<b>DOCKETED</b>	
<b>Docket Number:</b>	21-BSTD-01
<b>Project Title:</b>	2022 Energy Code Update Rulemaking
<b>TN #:</b>	238360
<b>Document Title:</b>	Home Ventilating Institute Comments - 45-day Language
<b>Description:</b>	N/A
<b>Filer:</b>	System
<b>Organization:</b>	Home Ventilating Institute
<b>Submitter Role:</b>	Public
<b>Submission Date:</b>	6/21/2021 3:20:35 PM
<b>Docketed Date:</b>	6/21/2021

Re: Docket No. 21-BSTD-01, 2022 Energy Code Update Rulemaking, Comments on 45-Day Language

**HVI Comment - CEC Draft Express Terms**

Re: Docket No. 19-BSTD-03, 2022 Energy Code Pre-Rulemaking, Draft Express Terms

**Figure 1.** Some ventilating fans are designed to deliver the targeted airflow when round ducts are slightly compressed to form an oval.

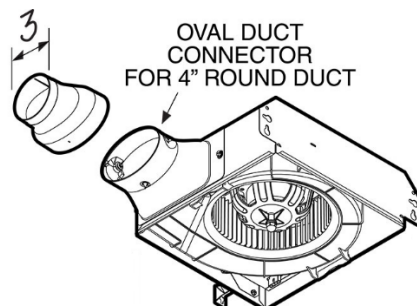
2. **150.0(m)1E and 160.3(b)5v** These sections prohibit compression of ventilation ducts within cavities. Generally, this is good practice. However, some ventilation fans are designed for compressed ducts in wall cavities. For example, some wall-mount exhaust fans accommodate 4" ducting that is slightly compressed to form an oval; such ducting has a greater hydraulic diameter than 3" ducting which would otherwise need to be used in a wall cavity to avoid compression (see image below). In this case, use of 4" round duct that is slightly compressed to form an oval can reduce static pressure, fan energy consumption, and coincident noise during fan operation. For these reasons, please consider modifying these sections as follows:

Ducts installed in cavities and support platforms shall not be compressed to cause reductions in the cross-sectional area of the ducts, except where approved by manufacturer installation instructions.
